RE: La Rinconada Facilities

I reviewed the drawings, and evaluated the site context. My comments and recommendations are as follows:

BUILDING 1

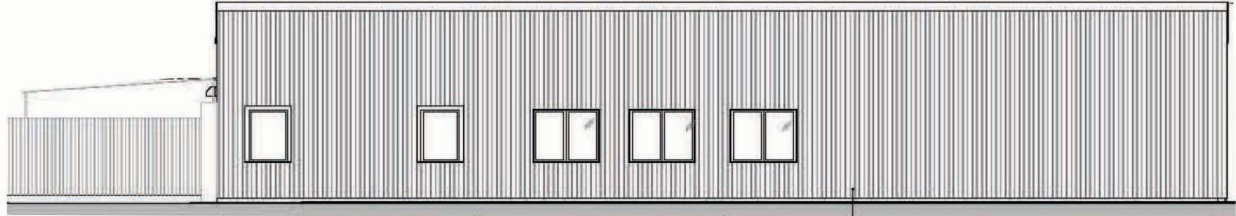
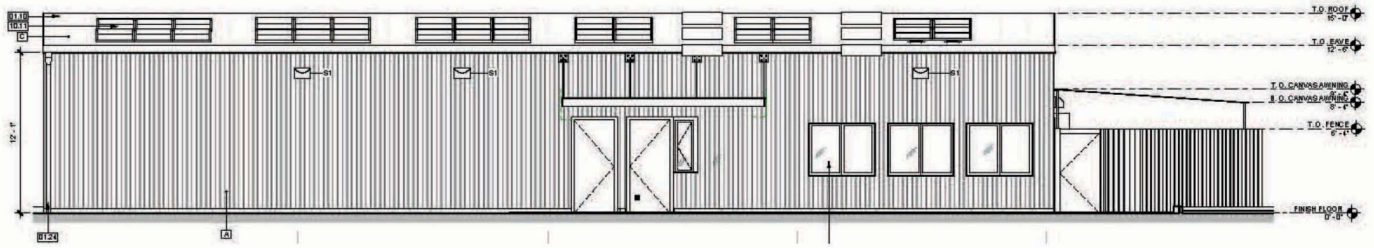
2. The proposed color scheme for the new buildings is quite bland with Ash Gray wall panels and White standing seam roofing.

2. The proposed color scheme, as noted, is quite bland while many similar golf course maintenance buildings have a bit more life to them. Consider a different combination of colors.

RESPONSE: WE RECOGNIZE THE NEED FOR ADDITIONAL COLOR BUT WANT THE NEW BUILDINGS TO BE AS NON-INTRUSIVE AS POSSIBLE. WE PROPOSES MANUF. STANDARD COLORS: 1) WALL (BODY & TRIMS): 'DESERT TAN' 2) METAL ROOF: 'WHITE'.

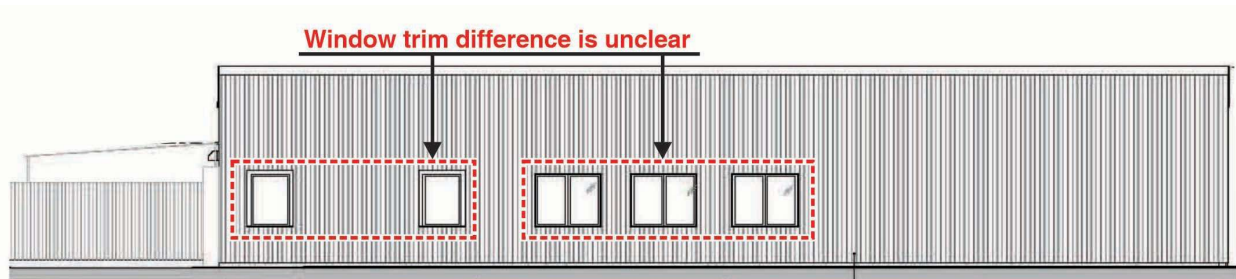
1. The proposed buildings are typical metal panel maintenance buildings. Each manufacturer has slightly different details and no typical details for the proposed buildings were provided in the submission drawings. There is one element that needs further explanation. The Building 1 elevation below shows different window trim on the same elevation.

1. Staff may want to ask the applicant for more manufacturer's details and photos of the proposed buildings.

RESPONSE: THE DRAFTING ERROR HAS BEEN CORRECTED. ALL WINDOW TRIMS WILL UTILIZE STANDARD EXTERIOR TRIM PROFILE AND MATCH.
